Product Change Notice (PCN)

PCN Number: **PCN-0450019R-01**

Product(s) Affected: **PJ-071**

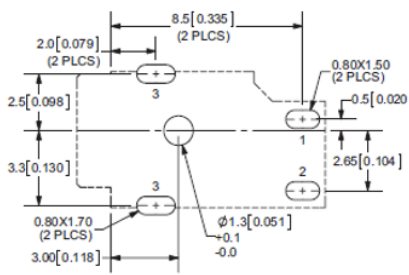
Description of Change: **Material Change. New PCB Dimensions included (pad sizes)**

PREVIOUS CUI DEVICES DETAIL / IMAGE			NEW CUI DEVICES DETAIL / IMAGE		
			 <p>Recommended PCB Layout Top View</p>		
	MATERIAL	PLATING	DESCRIPTION	MATERIAL	PLATING/COLOR
center pin	brass	tin	center pin	brass	tin
terminal 1	brass	tin	terminal 1	brass	tin
terminal 2	copper alloy	tin	terminal 2	copper alloy	tin
terminal 3	copper alloy	tin	terminal 3	brass	tin
plastic	PAB6		housing	PBT (UL94V-0)	black
